# Technical Note

<b>To</b> Environment Agency	<b>Client</b> bp	<b>Subject</b> H2Teesside Water Quality Impact Assessment	<b>Date</b> 25 September 2024
<b>Issued by</b> AECOM	<b>Reason for issue</b> Responses to Outstanding Questions	<b>Prepared by</b> Sarah Waite	<b>Checked by</b> Caroline Braithwaite
<b>Approved by</b> Tamara Percy	<b>Revision No.</b> 2

Figure 1: H2Teesside Site Water Flow Diagram and Balance

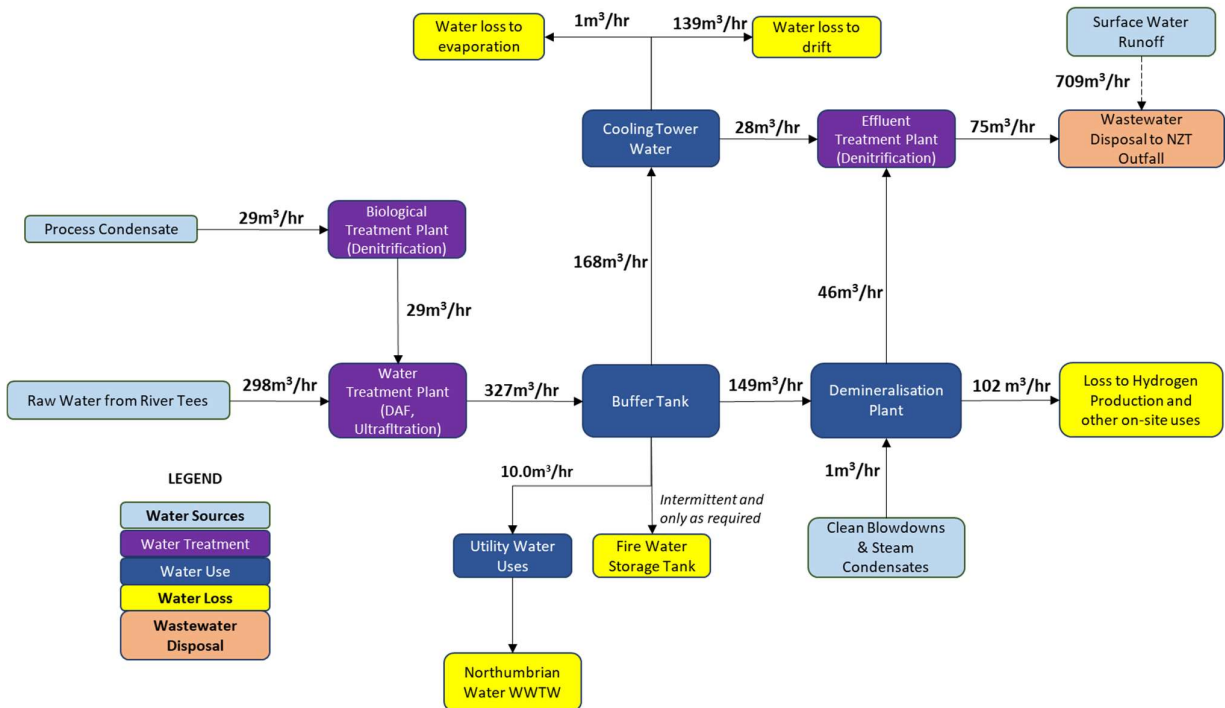
2. The Agency requested further information on how the values used to calculate the effluent flow rate and pollutant load have been derived. The available information is set out below under "Calculation of Effluent Profiles."

3. The Agency requested the raw data, process unit's effluent profiles, effluent treatment unit's design specifications, list of assumptions and supporting narrative to understand how the final effluent quality and compositions have been calculated. The available information is set out below under "Calculation of Effluent Profiles."

The H2Teesside site remains at an early stage of design and full details of process unit's effluent profiles and design specifications were not available at the time of the dispersion modelling. The information available at the time of the dispersion modelling carried out for this site allowed for the construction of the site water flow diagram and site water balance in Figure 1. The assumptions concerning water use and effluent generation from each unit are outlined below.

- Process condensate is generated through condensation of steam in the carbon capture process and may contain dissolved nitrogen from the carbon capture process. The contribution of the process effluent to the site nitrogen balance and eventual effluent nitrogen load has been accounted for in the dispersion modelling outlined in the Water Quality Impact Assessment. Since the process effluent mainly consists of steam condensate, it is assumed not to contain any other contaminants.

- Prior to entering the main site water supply system, the process condensate will be treated via a biological denitrification plant which will convert some of the nitrogen load to nitrogen gas for atmospheric release. Full details of this treatment plant were not available at the time of the Water Quality Impact Assessment but a final effluent nitrogen load of 15mg/l was specified in the information provided by bp to inform that assessment. This is assumed to be present in the form of nitrite, nitrate and/or ammonia, all limited under the Dissolved Inorganic Nitrogen (DIN) standard in coastal waters under the Water Framework Directive.

- The effluent from the biological treatment plant will be combined with raw water from the non-tidal River Tees within an additional water treatment (filtration) plant. The quality of the River Tees water has been characterised with reference to information supplied by Northumbrian Water and the Environment Agency and included with this note. The data are obtained via analysis of samples taken from the non-tidal River Tees at the three Northumbrian Water abstraction points at Low Worsall, Blackwell and Broken Scar and from Environment Agency sampling locations (<https://environment.data.gov.uk/water-quality/view/explore>). A full specification of the water treatment plant used to treat the combined River Tees and treated process condensate streams was not available to support the discharge modelling but the information available showed that the plant would include dissolved air filtration (DAF) and ultrafiltration. For the purposes of the water quality modelling, as a worst-case scenario it was assumed that the treatment plant removed particulate matter only and did not impact on concentrations of dissolved substances. No water loss was allowed for at this water treatment stage.

- Following treatment by DAF and ultrafiltration, water is stored in a buffer tank on site. The dispersion modelling assumes that the purpose of this tank is to account for changes in water demand on the site and the storage does not result in any change to water chemistry. A small amount of water from this tank is taken to meet on-site utility water requirements and top up a fire water storage tank. The effluent from the utilities is disposed of to the public sewer system and the fire water is only required in an emergency. This water use only acts to reduce the amount of water reaching the NZT outfall and does not change the effluent chemistry.

- The majority of the water stored in the buffer tank is required for use in cooling towers. The water is heated at the cooling tower stage which results in a significant water loss through evaporation and drift. For the purposes of the

water quality impact assessment, as a worst-case scenario it was assumed that all water lost at this stage was pure water only and all dissolved contaminants in the water supplying the cooling towers were retained and concentrated within the cooling tower effluent. Since the main process at this stage is heating only, it was also assumed that no additional dissolved contaminants would be added to the cooling tower effluent.

- The buffer tank water is also to be used to supply a demineralisation plant which is used to generate pure H<sub>2</sub>O for the purposes of supporting hydrogen production. All H<sub>2</sub>O generated by demineralisation plant is considered to be lost from the on-site water balance. All contaminants in water supplied to the demineralisation plant will be passed into the demineralisation plant effluent. A full technical specification of the demineralisation plant was not available to inform the dispersion modelling, so for the purposes of the water quality assessment it was assumed that no additional contaminants would be added to the wastewater streams at this point.

- The combined wastewater from the cooling towers and demineralisation plant is conveyed to an additional biological denitrification plant with the aim of reducing the DIN concentrations in the final effluent discharged from the site. A full technical specification for the denitrification plant was not available at the time of the dispersion modelling but a final effluent nitrogen load of 15mg/l was specified in the information provided by bp to inform that assessment. The treatment plant was assumed to impact on dissolved forms of nitrogen only because the impact on other dissolved substances is not known. The plant is assumed not to add any additional substances to the final effluent discharged to Tees Bay.
